# TOWN OF BELMONT HIGH SCHOOL

## MODULE 3: PREFERRED SCHEMATIC REPORT

FEBRUARY 16, 2018

OPTION 2.1 CLARIFICATION OF SCOPE

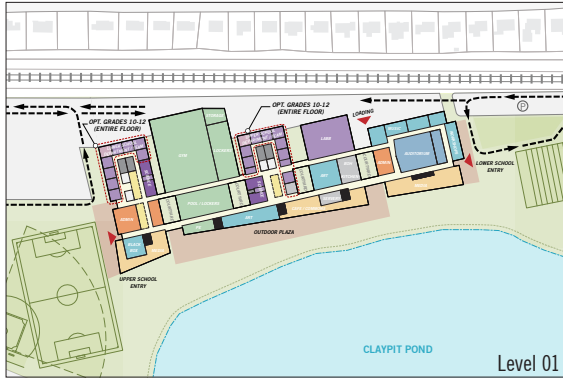
*As detailed below in section 3.1.6 Preliminary Evaluation of Alternatives, MSBA requests that the District/design team include an add/reno option for consideration in the following PSR submittal that includes the minimum renovation and addition required to meet current code and comply with the educational program.*

DOCUMENT # 4

## OPTION 2.1 A LIGHT TOUCH MAJOR RENOVATION MINOR ADDITION

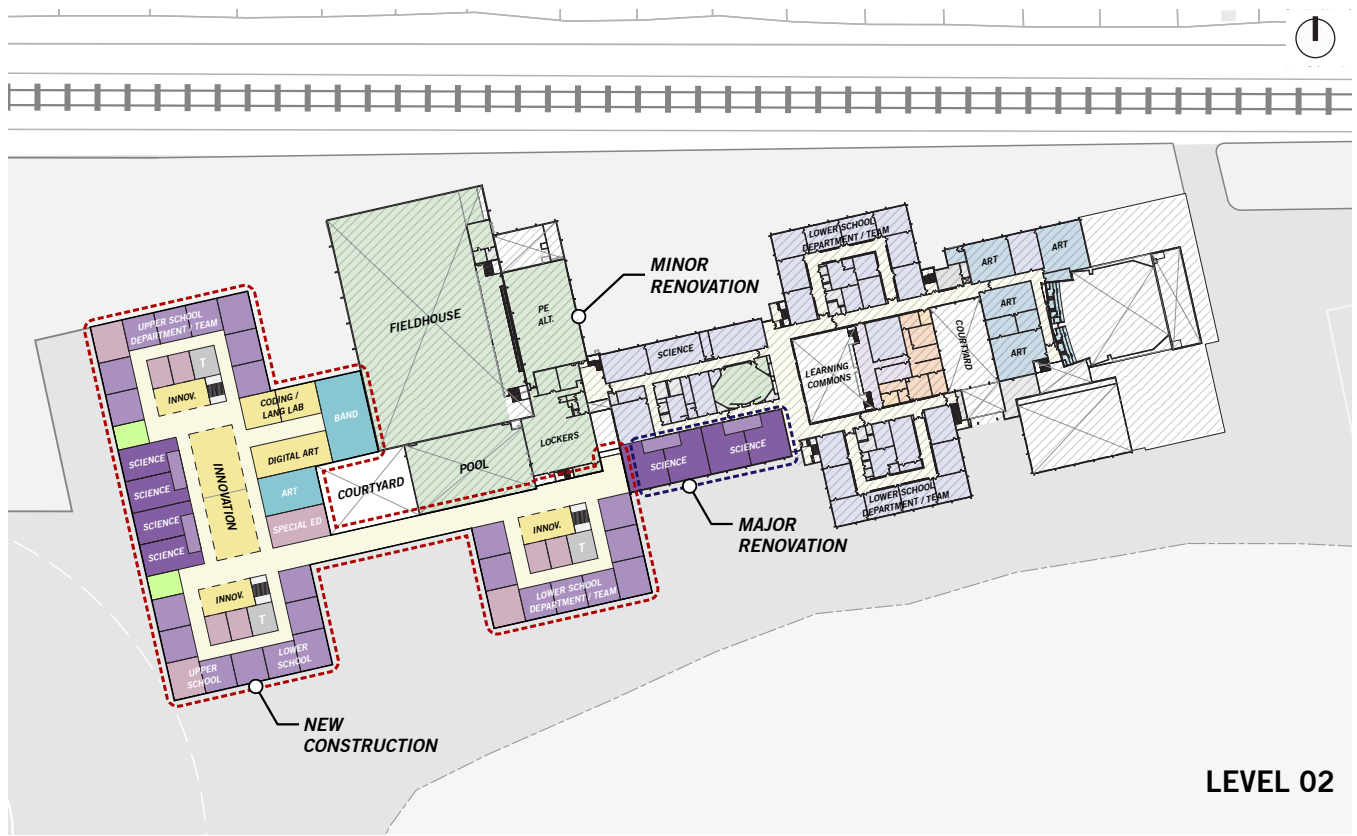
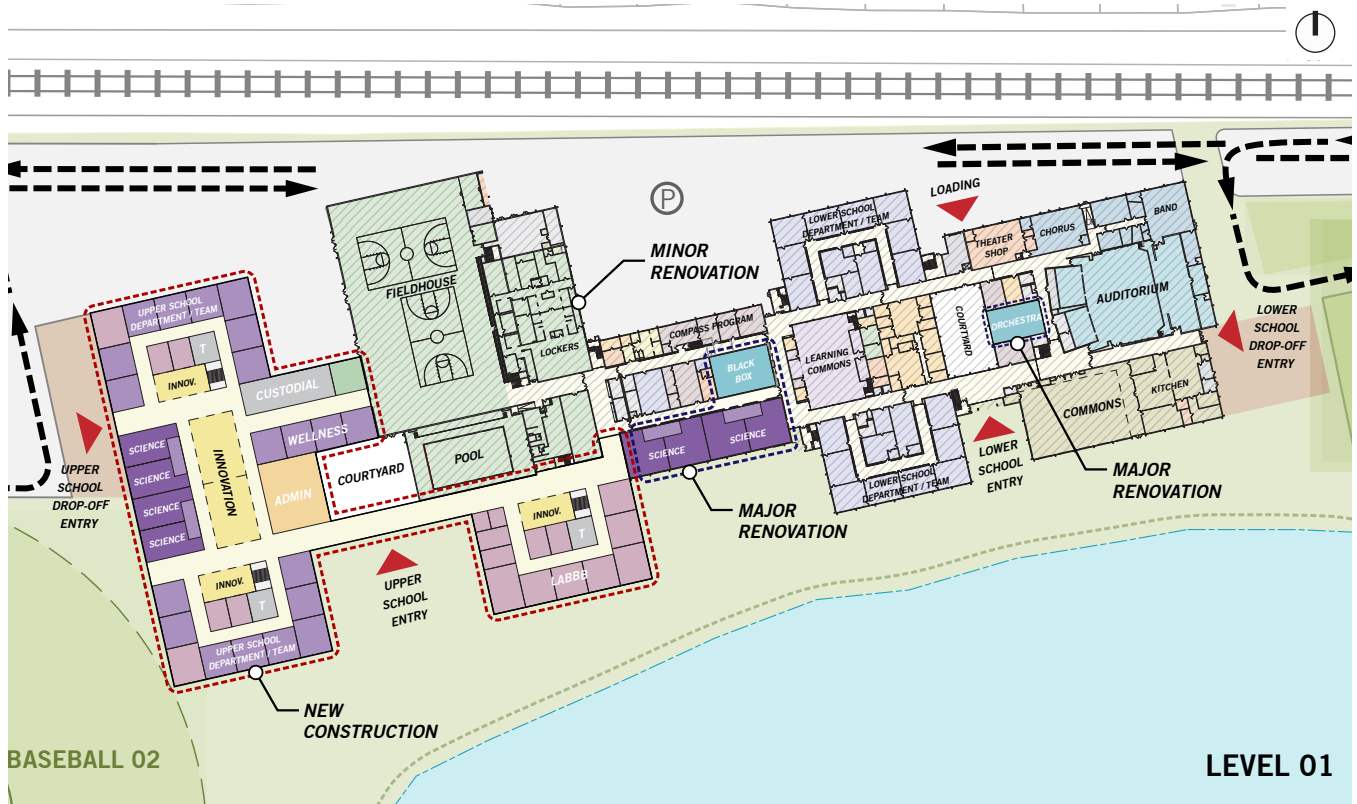
The following summary includes Project Costs with both hard and soft costs. Option 2.1 a is considered in response to the MSBA PDP letter and was reviewed by the BHSBC, cost estimator, OPM for content, project duration, and cost. The information

# G. DISTRICT RESPONSE / Addenda #1
